ADDENDUM NO. 1
06/10/2024

PROJECT: CITY OF VERNON
FERRELL STREET LIFT STATION RECONSTRUCTION

SECTION B-B

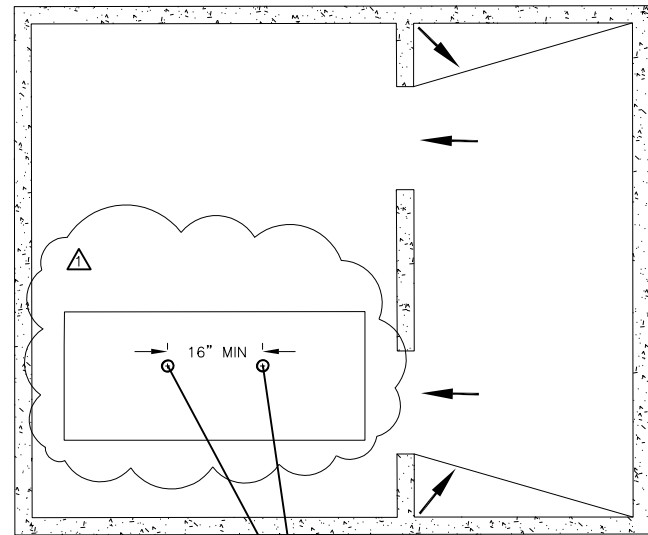
Sheet 4 – Miscellaneous Details – This sheet has been revised to correct the lift station vault location on Section B-B. Section A-A has also been revised to show circle saw cuts on the pass-through wall instead of squares. A note was also added to this sheet to provide details on rebar protection near the saw cut areas.

- 1) CONTRACTOR TO MAINTAIN 10% FLOOR SLOPES PER TAC 217.61(e)(1).
- 2) CONTRACTOR TO GROUT BOTTOM OF LIFT STATION TO SLOPE FLOOR TO PUMP LOCATIONS.
- 3) CONTRACTOR TO COAT PROPOSED SAW CUT CHANNEL HOLES WITH TNEC SERIES 436 OR APPROVED EQUAL.
